Figure 45: Summary of observed effects, and the mean levels of the exposure for human studies of exposure to electromagnetic radiation. All epidemiological studies occur below the ICNIRP and New Zealand Standard of allowable exposure.

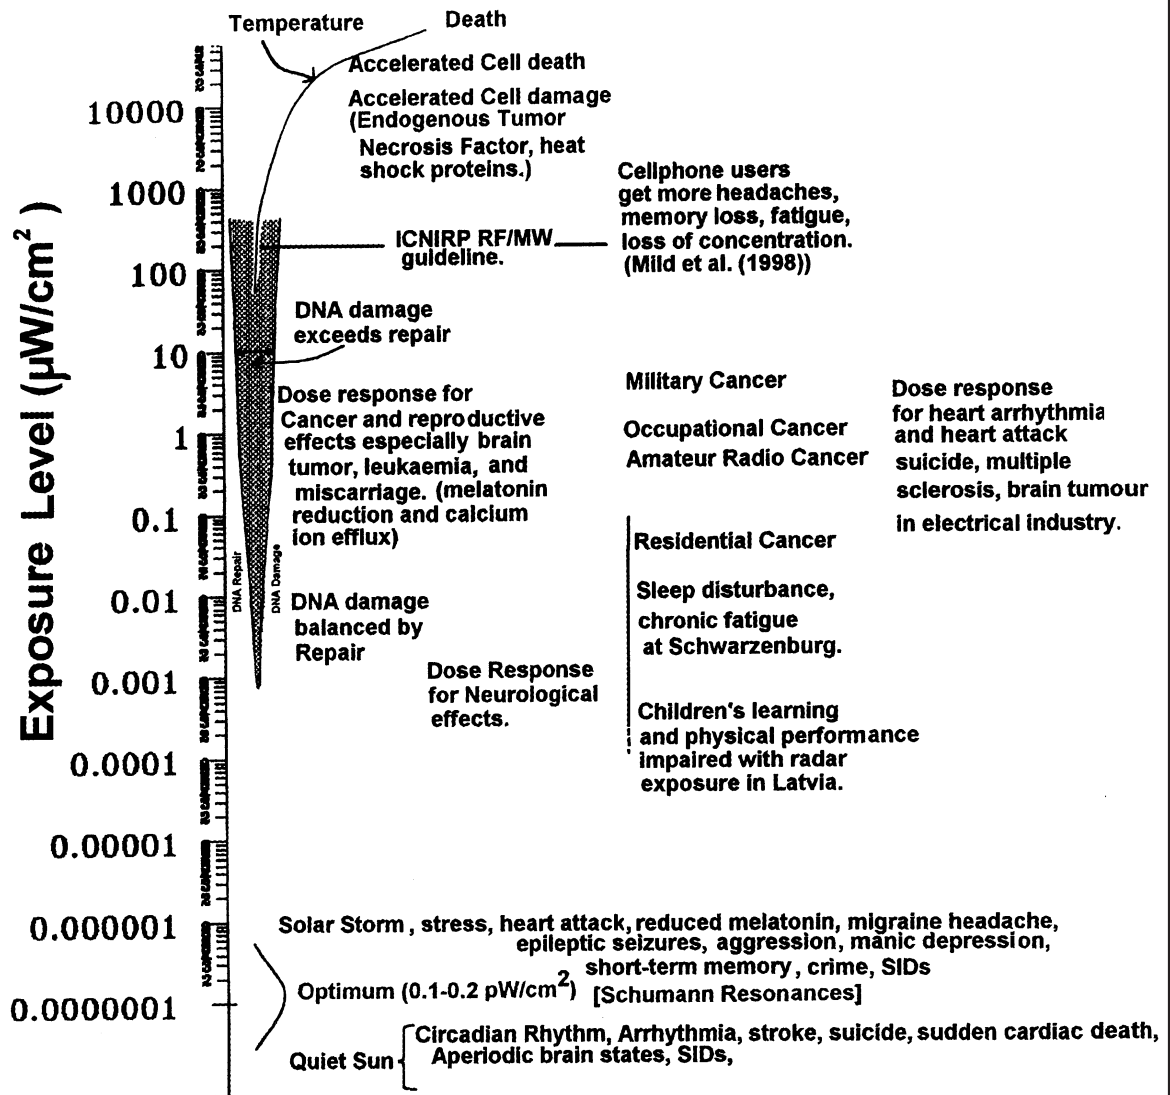
Since calcium ion efflux and melatonin reduction are established biological effects of EMR exposure from ELF to RF/MW, impair immune systems should be observed in EMR exposures. Multiple independent evidence is available for RF exposures, down to extremely low chronic mean levels, and many dose response relationships are established to prove that these biological effects from EMR exposure is genotoxic. Significant DNA strand breakage has been observed down to $1 \mu \text{W}/\text{cm}^2$, Phillips et al. (1998), with elevated DNA damage below this. Therefore there is extremely strong evidence that EMR across the spectrum is genotoxic, even at very low exposure levels found in the vicinity of cell sites, Figure 45.
